75W MODIFICATION TO APPLICATION TO  
BARANGAROO CONCEPT PLAN (MP06\_0162 MOD 8)

## MOD 8 DRAFT CONDITIONS | PART B – MODIFICATIONS TO CONCEPT PLAN **RESPONSE TO CONDITION B3**

16 FEBRUARY 2016

WATERMANS COVE PROPOSED AMENDMENT

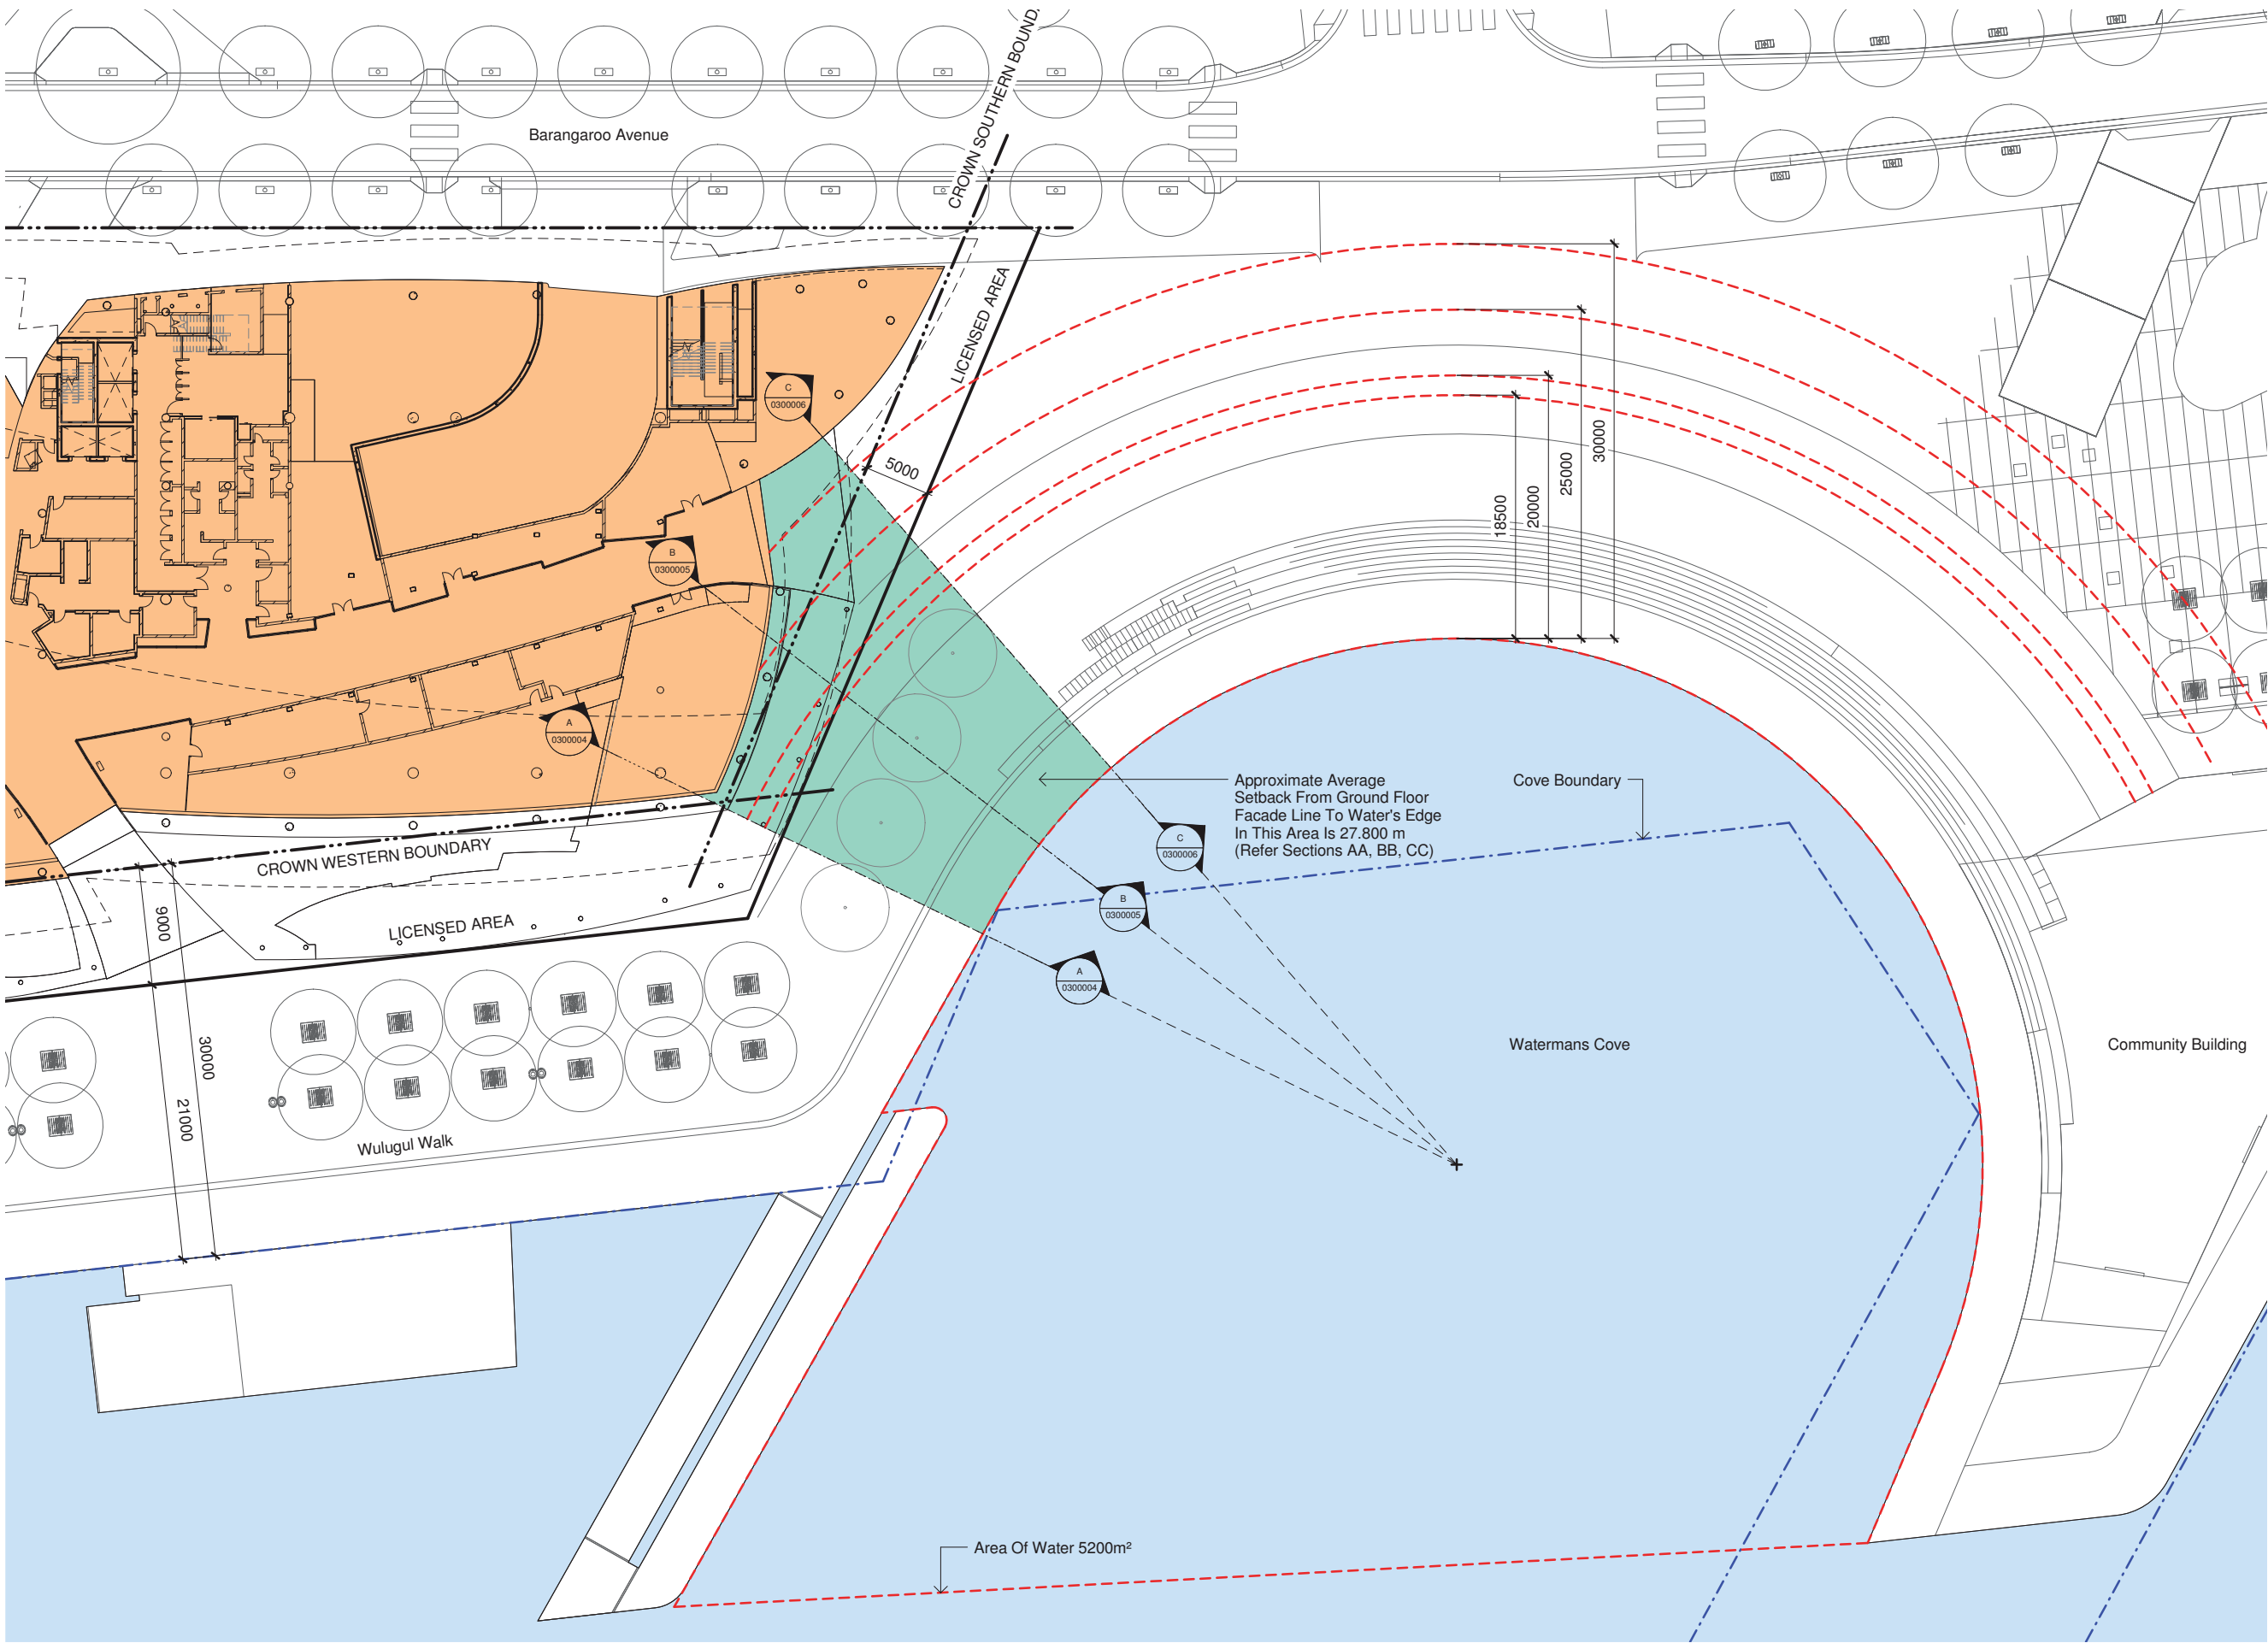
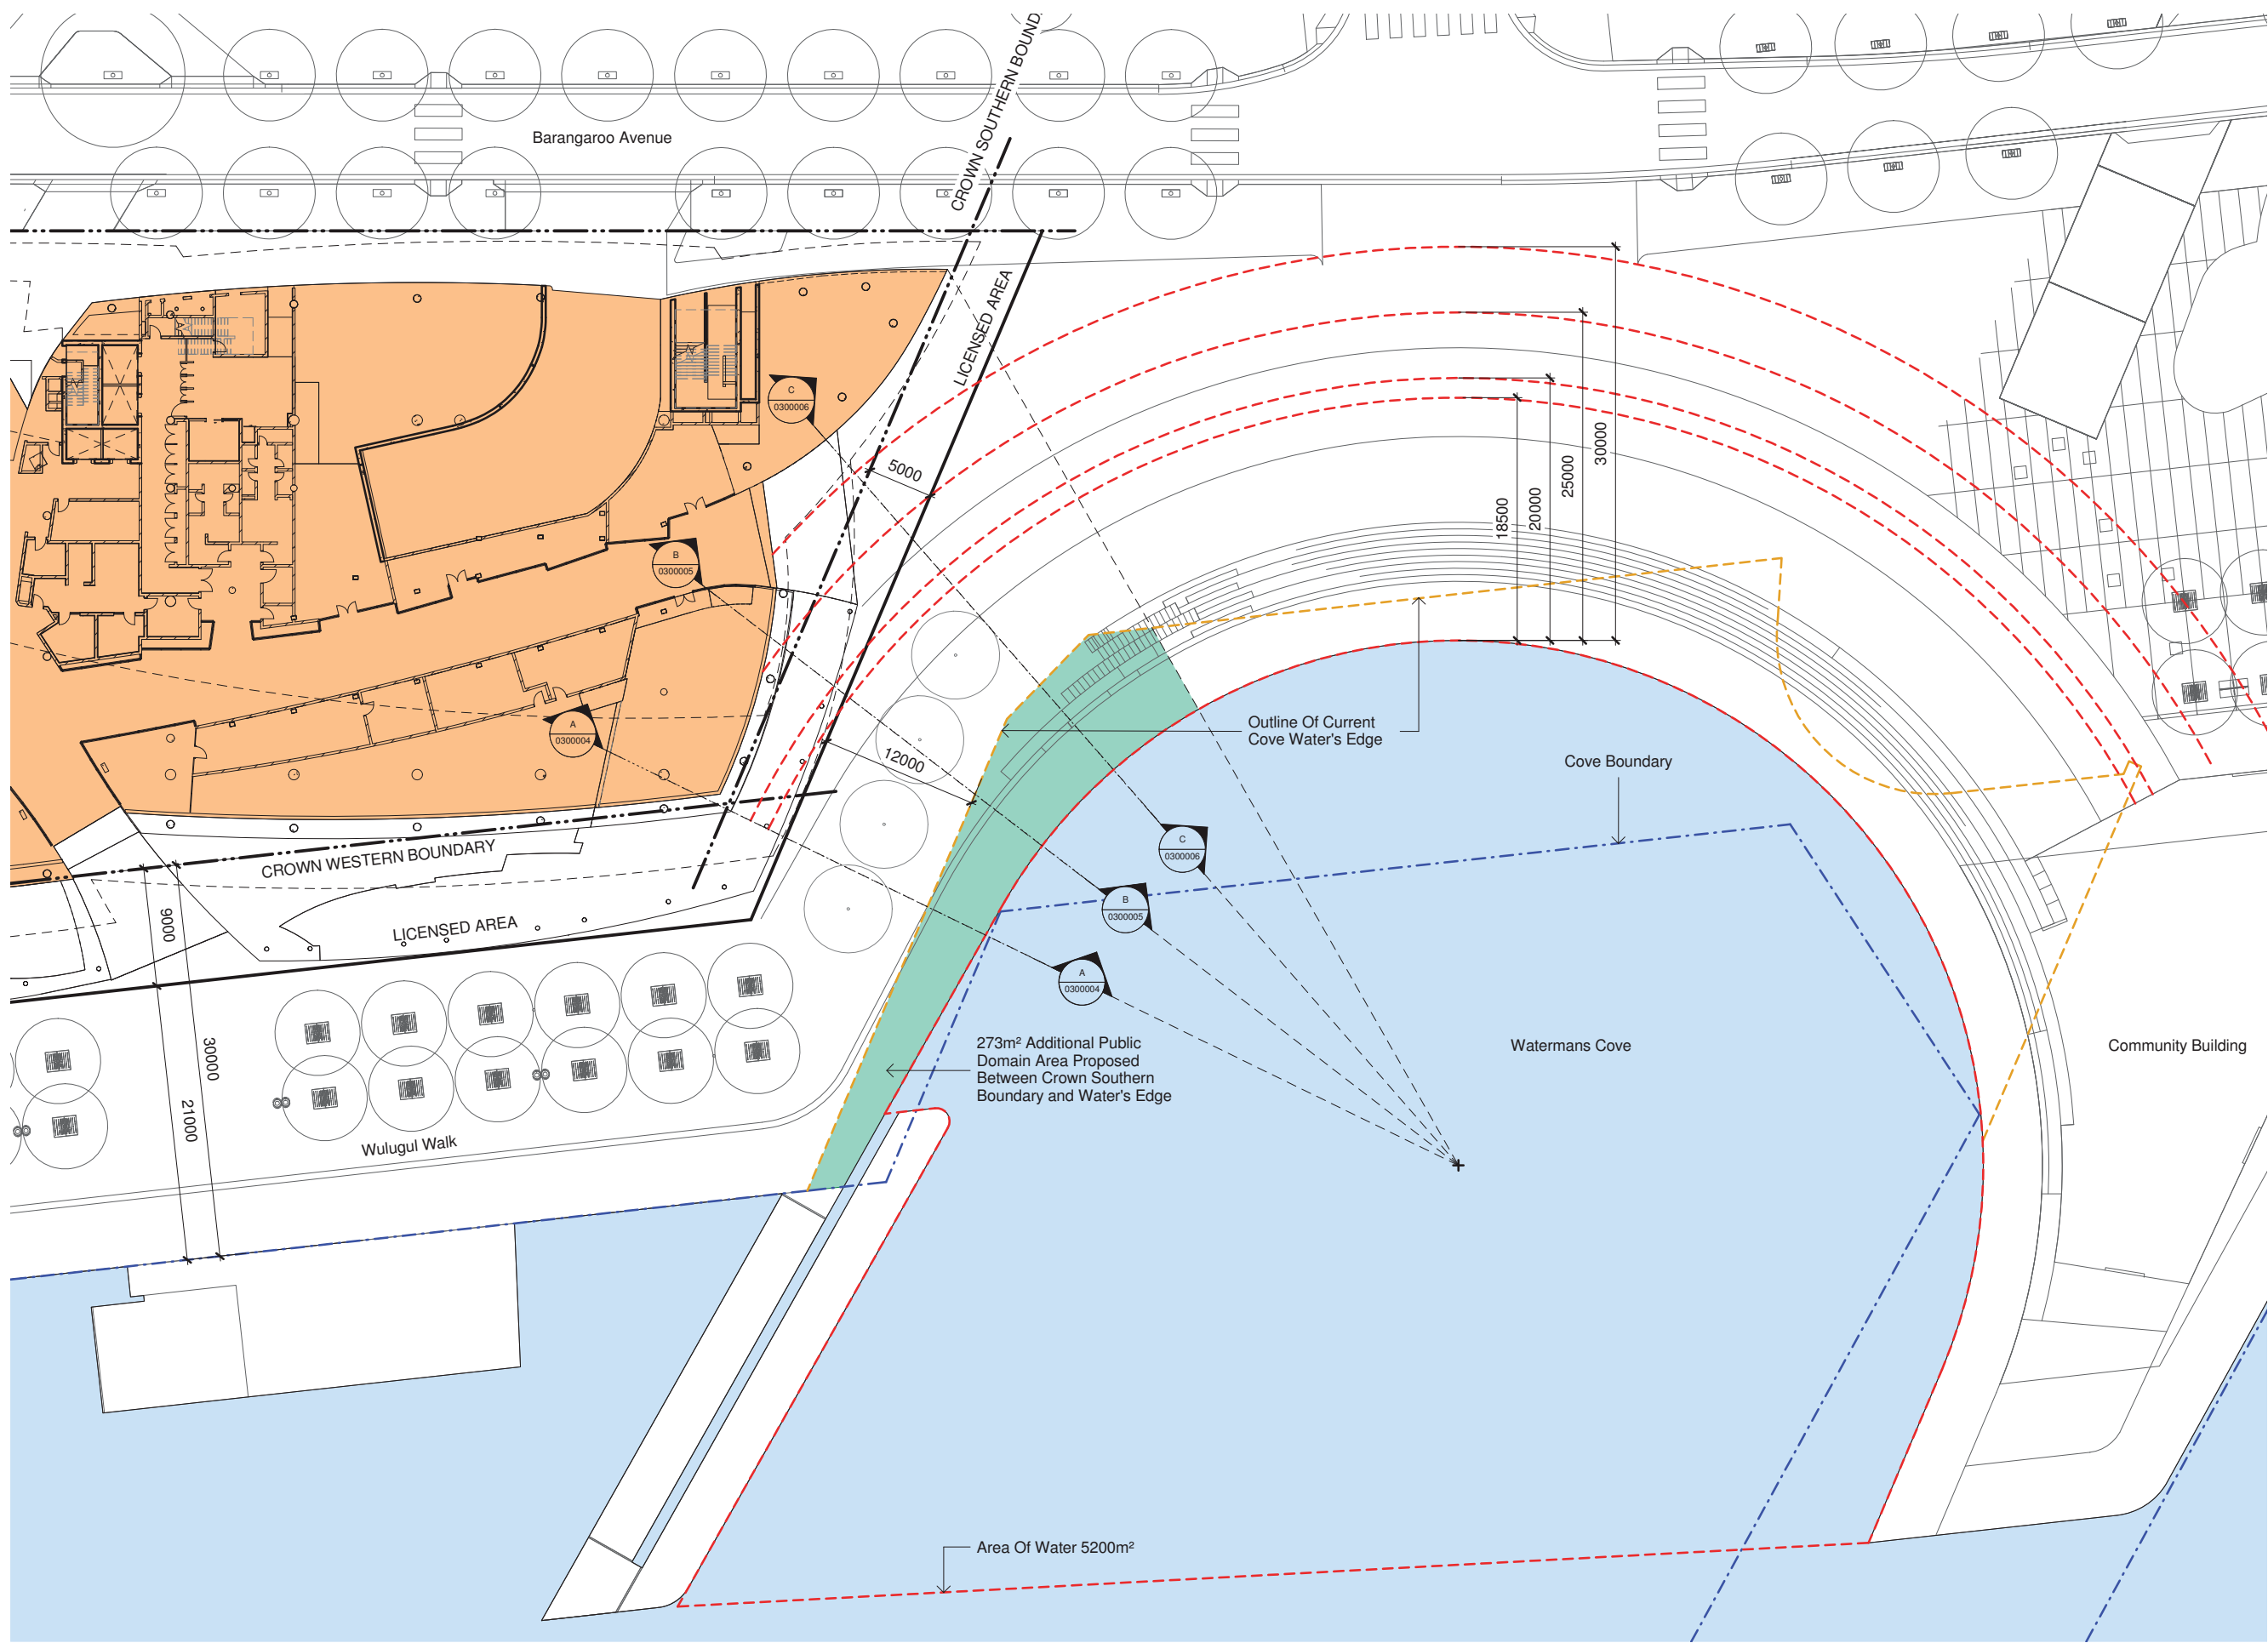
As a proposed design revision and solution to resolve the underpinning objectives, we have included the attached indicative design of Watermans Cove that now provides for an average 27.8 metre setback between the CSHR podium on Block Y and the northern edge of the future Watermans Cove. The proposed design of Watermans Cove will additionally increase the overall Public Promenade area to the south of the CSHR podium by 273m<sup>2</sup> whilst provide a minimum 18.5 metre wide clear unobstructed Public Promenade along the waters edge. The minimum 18.5 metre wide clear unobstructed Public Promenade along the edge of Watermans Cove is consistent with the minimum 18.5 metre wide clear unobstructed Public Promenade that has been established along the harbour edge to the south in front of R8 and R9.

Additional Public Domain Area Indicated

**Section A-A (Current)**

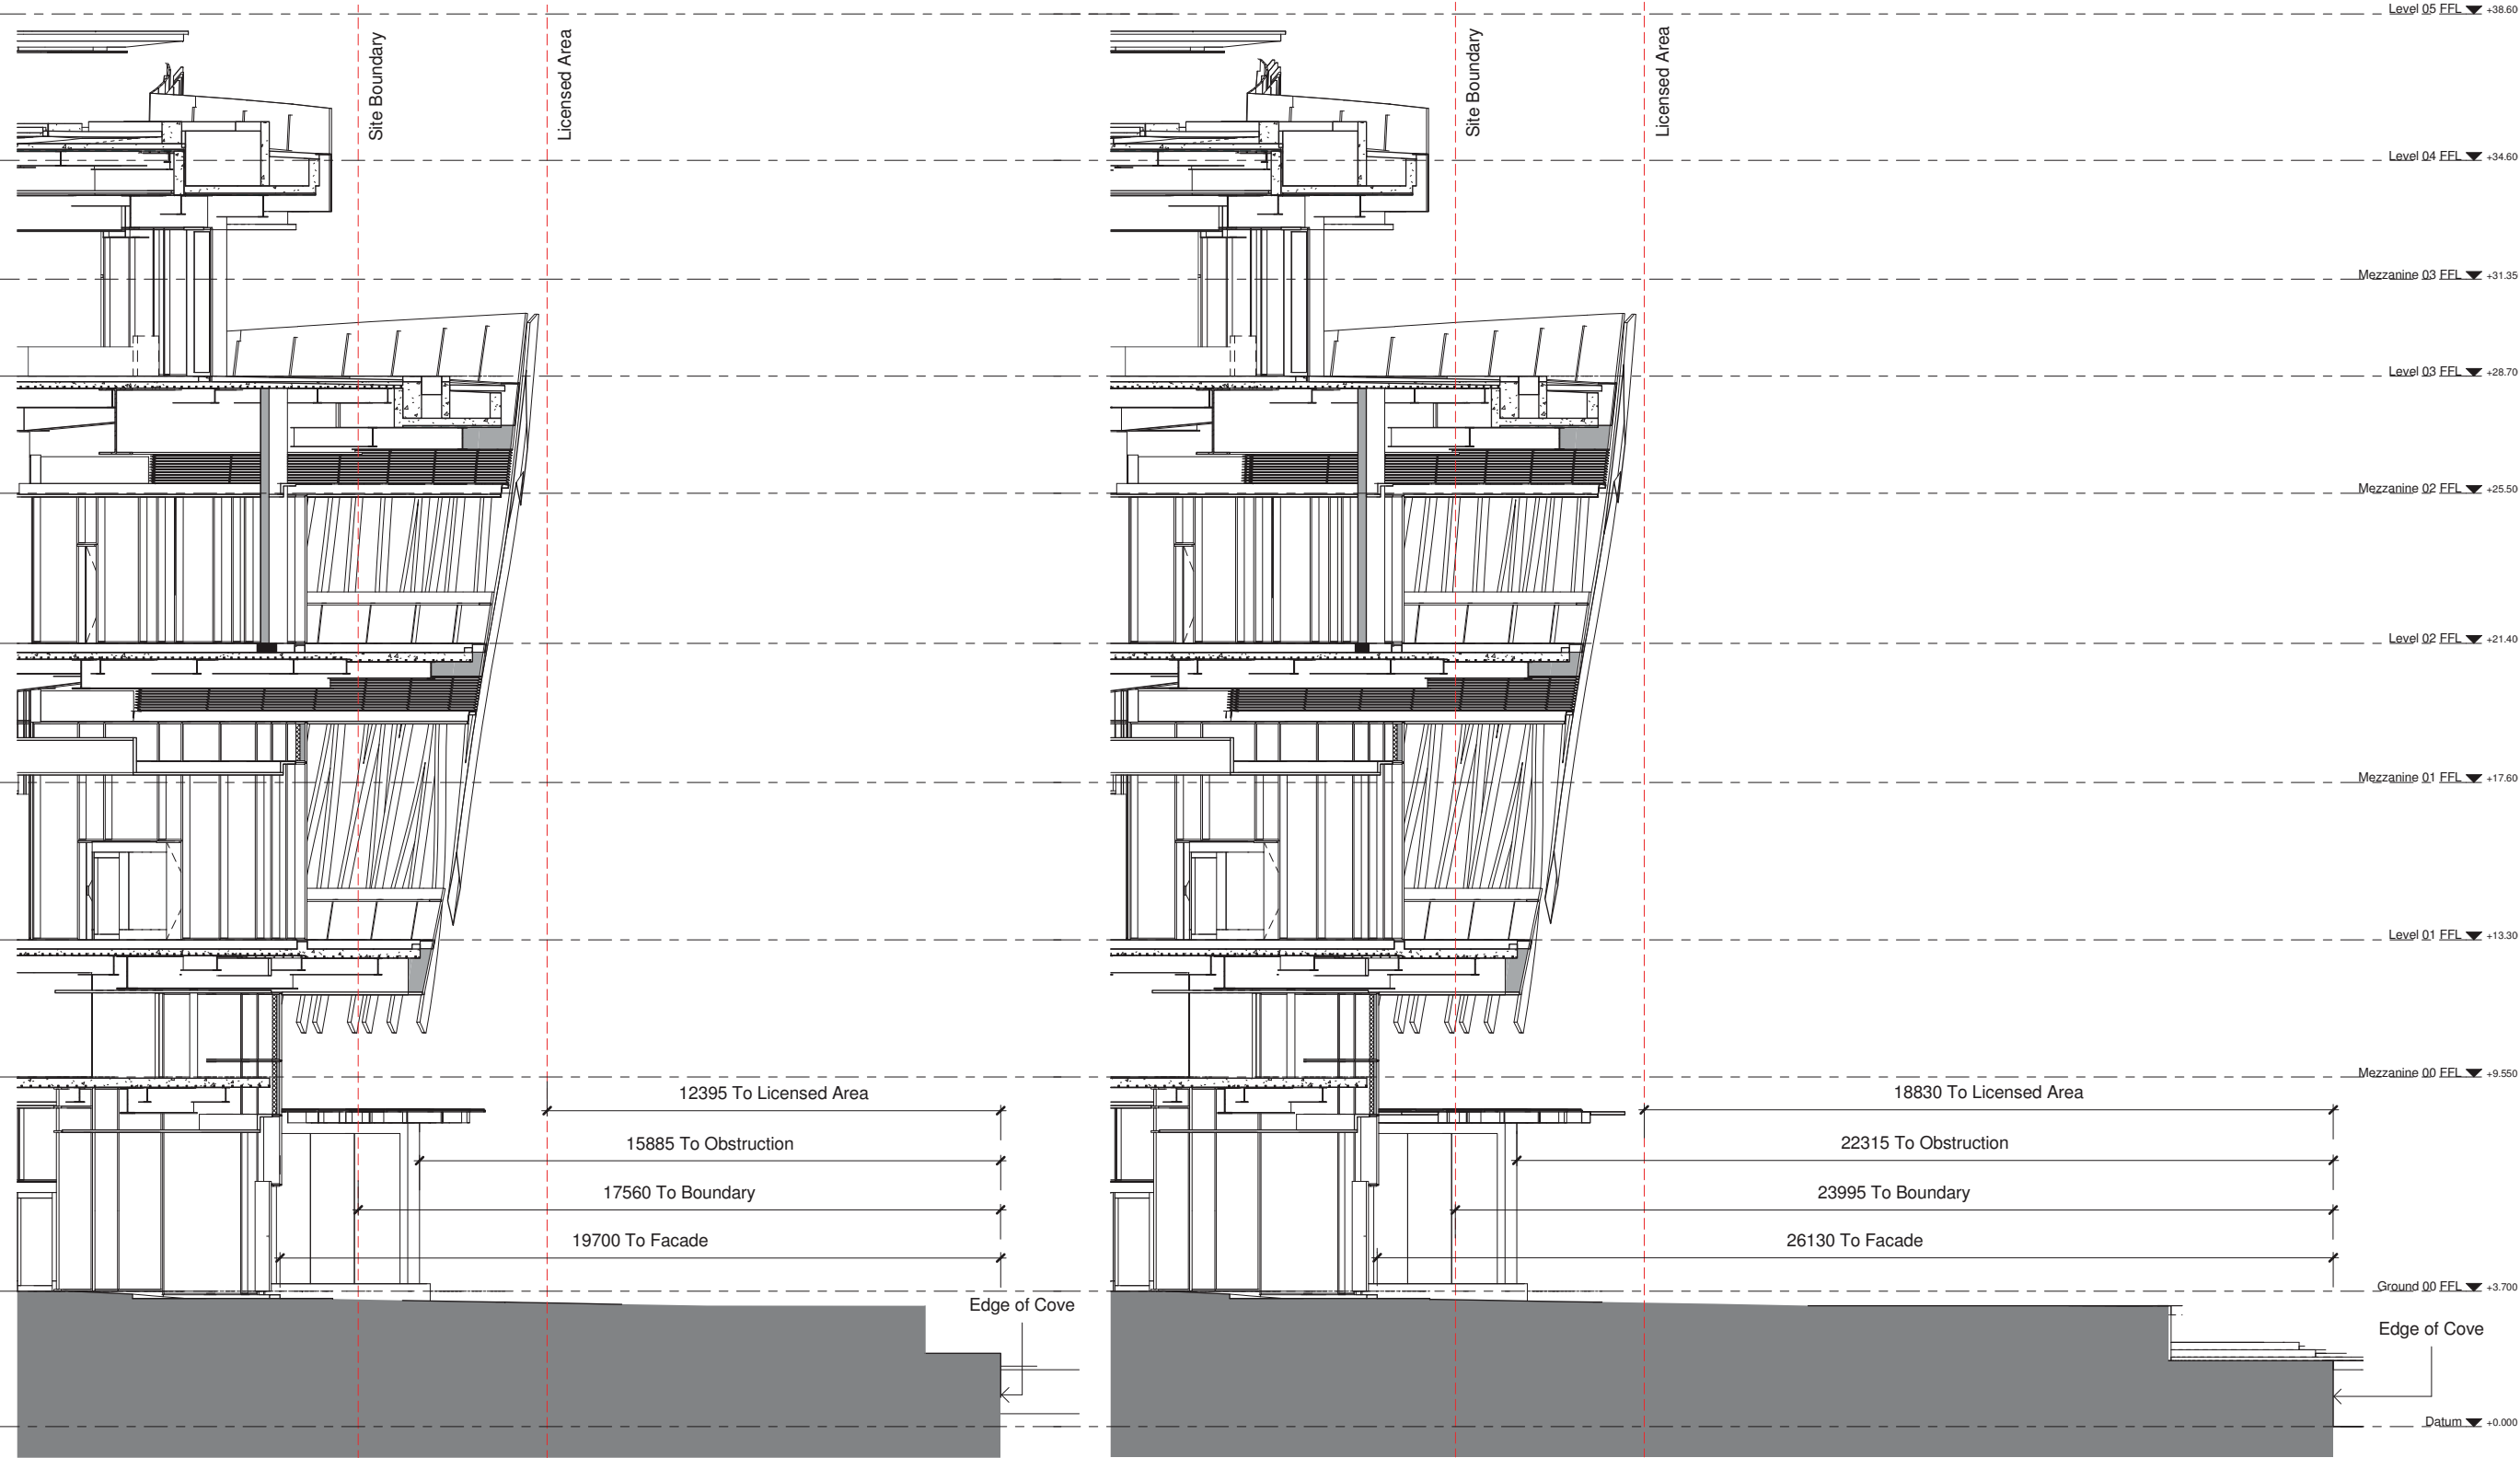
In addition to increasing the setback of the podium from the waters edge, Crown Resorts is proposing to modify the design of the southern podium elevation per the attached plans in an effort to minimize any perception that the podium dominates and overwhelms Watermans Cove.
